NORTHEAST UTILITIES

Millstone Nuclear Power Station, Unit No. 3
Supplement 1 to NUREG-0737
Safety Parameter Display System

Response to NRC Staff's Letter Dated November 28, 1984

FIGURE 1 PROCESS COMPUTER FUNCTION KEYBOARD

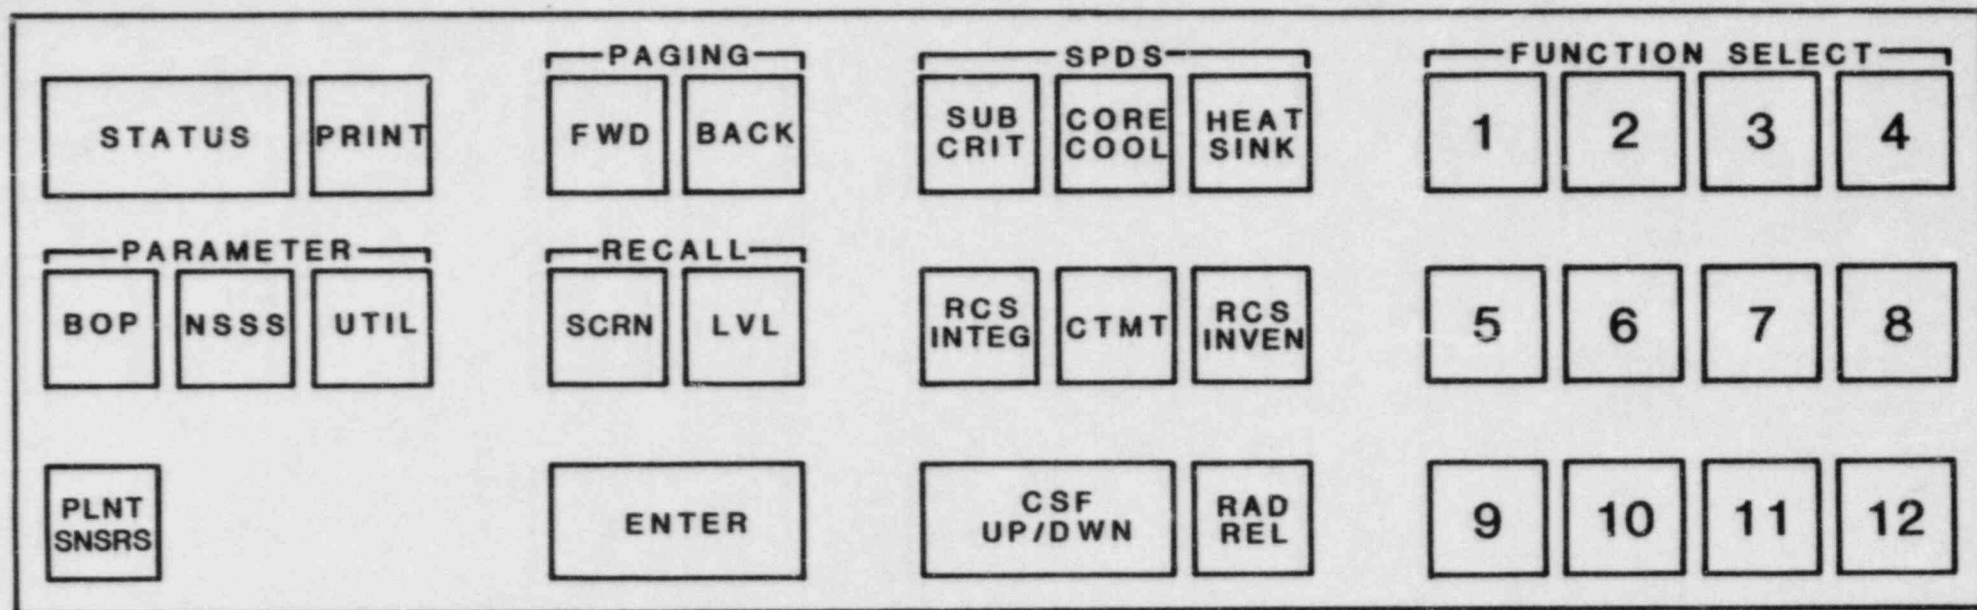
Provide a description of the display system, with emphasis on its human factored design, and the methods and results of a human factors program to ensure that the displayed information can be readily perceived and comprehended so as not to mislead the operator. Color photographs or reproductions of display pages and interface devices may be helpful in supporting the discussion.

Section 7.0, entitled Human Factors Engineering, of our SAR has been revised and is included in Attachment No. 4. A representation of the process computer function keyboard and copies of the SPDS displays can be found at the end of this attachment. Some changes may be made to these displays, as well as the keyboard configuration, prior to fuel load. Three sets of colored displays are being submitted to the NRC Human Factors Engineering Branch. More detailed information can be provided to the NRC Staff during the SPDS audit.
